Montgomery County Historic Preservation

Staff Report

<p>ADDRESS: 19 Grafton Street, Chevy Chase</p> <p>RESOURCE: Chevy Chase Village Historic District</p> <p>APPLICANT: Joshua Bonnie & Kelly Bonnie (Yilu Zhang, Architect)</p> <p>REVIEW: Preliminary Consultation</p> <p>CASE NO.: Pending</p> <p>PROPOSAL: Construction of second-story addition</p>	<p>MEETING DATE: 5/13/2026</p> <p>REPORT DATE: 5/6/2026</p> <p>PUBLIC NOTICE: 4/29/2026</p> <p>TAX CREDIT ELIGIBLE: No</p> <p>STAFF: Laura DiPasquale</p>
--	--

The applicants propose to construct a second-story sunroom addition over an existing roof deck and porch.

Figure 5: Left, existing second-floor plan. Right, proposed second floor plan. A red arrow shows the section of roof to be removed.

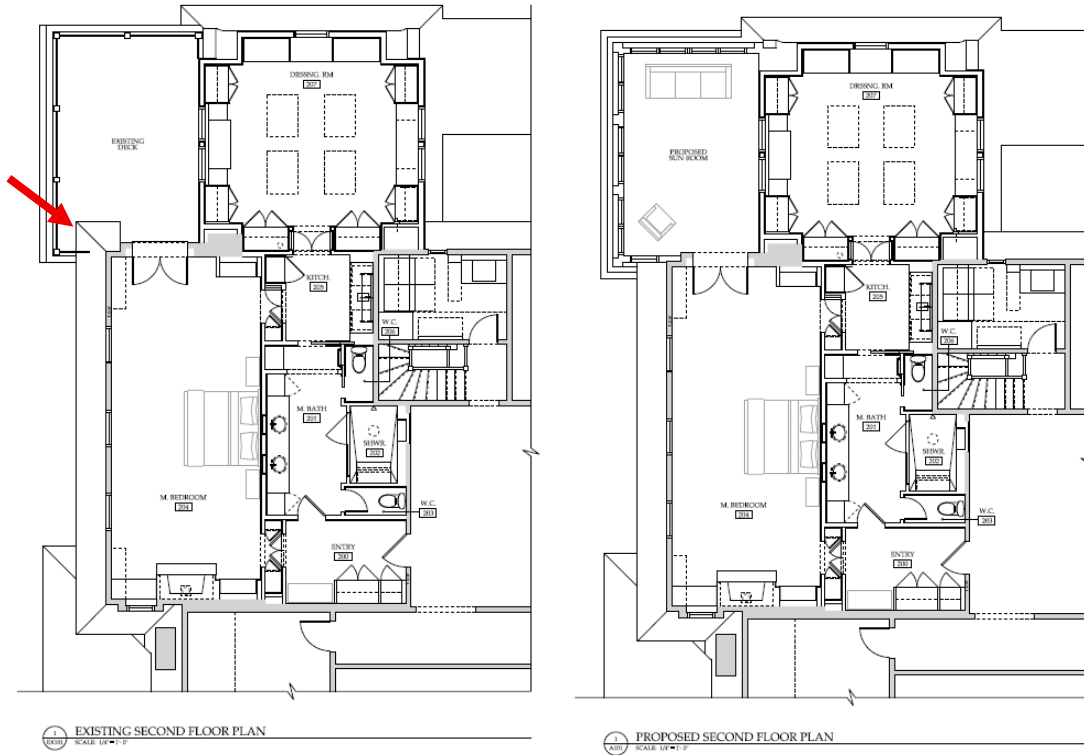
Staff finds that, although the applicants identify the enclosure as being constructed within the existing deck footprint, the proposed addition will fully remove the rear corner and return of the existing character-defining historic side gambrel roof, irreversibly altering the historic roof form and running counter to Chapter 24A-8(b)(1) and *Standards 2, 9, and 10*. Staff notes that although the existing roof deck railing connects to the historic gambrel roof, the deck did not require the removal of any historic fabric and the full form and return of the roof is intact.

Staff further finds that the design of the proposed addition competes for supremacy with the historic building in massing, fenestration, and design, counter to *Standard 9* and Chapter 24A-8(b)(2). Staff finds that, unlike the approved 2020 addition, which is inset from the side wall plane of the historic house and not visible from the public right-of-way, the proposed addition projects beyond the side wall plane of the historic house, altering the original massing and form of the historic house as viewed from the public right-of-way. Staff further finds that multiple window types and muntin patterns draw additional attention to the proposed addition, counter to *Standard 9* and recommendations for new exterior alterations presented in the Secretary of the Interior's *Guidelines for Preserving, Rehabilitating, Restoring & Reconstructing Historic Buildings*, which extrapolate on the more succinct *Standards*.

Staff recommends that any second-story addition to the subject property not extend beyond the side wall plane of the existing rear dormer so as not to disrupt the historic roof and building form.
